ADDENDUM No. 2

July 11, 2017

**NC Department of Transportation
Wagram Equipment Shop
Scotland County, NC**

SCO ID# 14-11279-01A

PAVEMENT REPAIR DETAIL

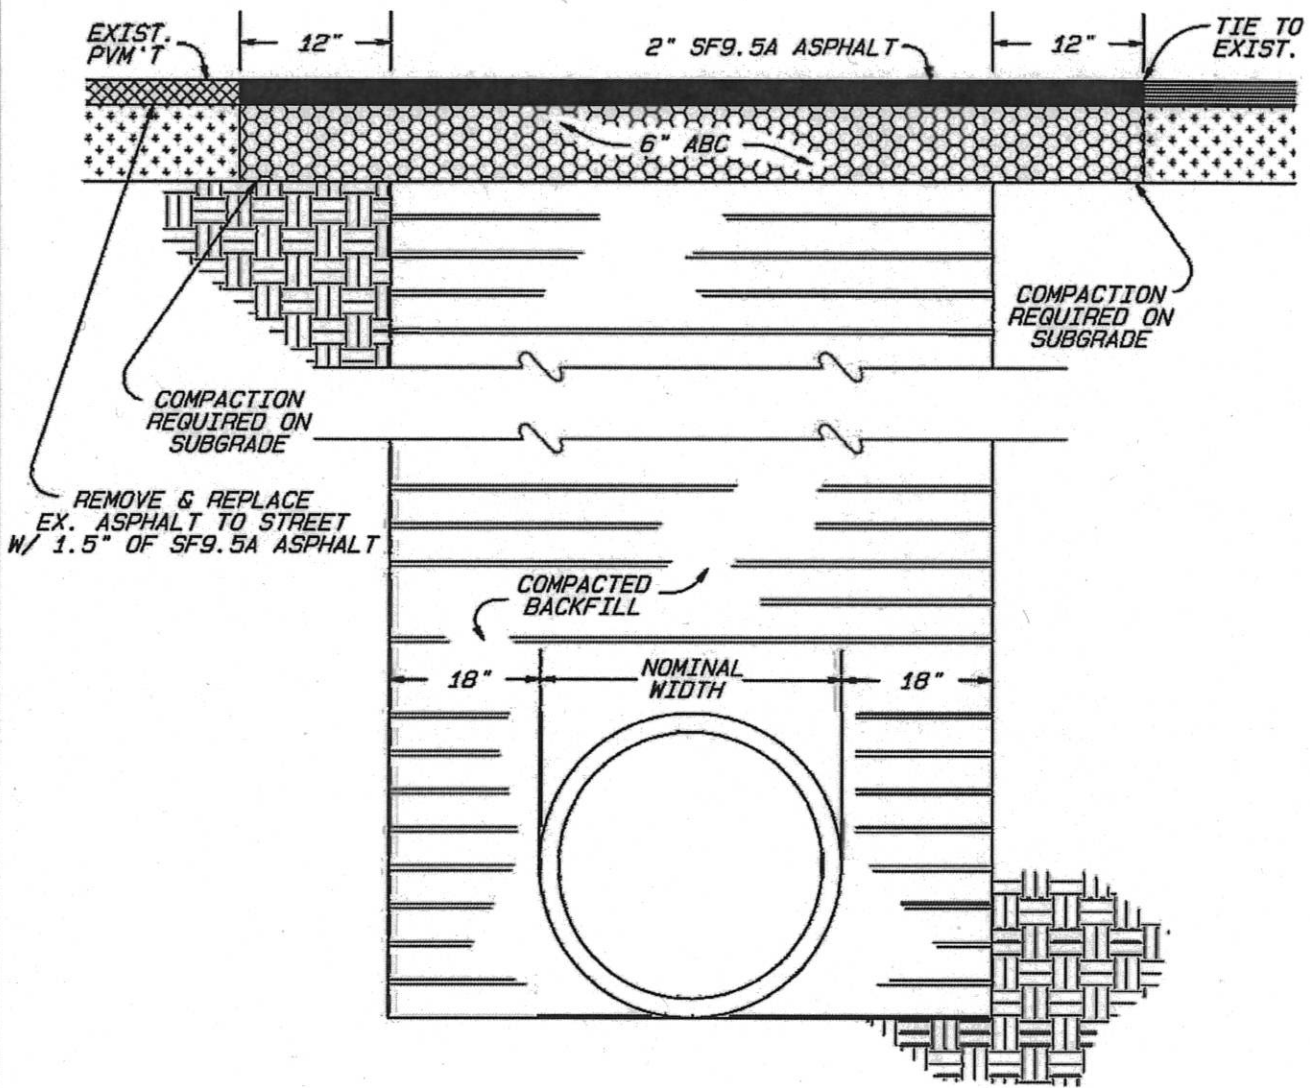
4. Construction Plan, Sheets C2.0 and C3.0: Upon installing the proposed 15" RCP under the existing pavement area of the existing NC DOT site to make the storm drain connection, the pavement shall be repaired in accordance with the attached detail requiring 2" 9.5A Surface Course and 6" CABC over the compacted subgrade disturbance. See attached "Pavement Repair Detail".
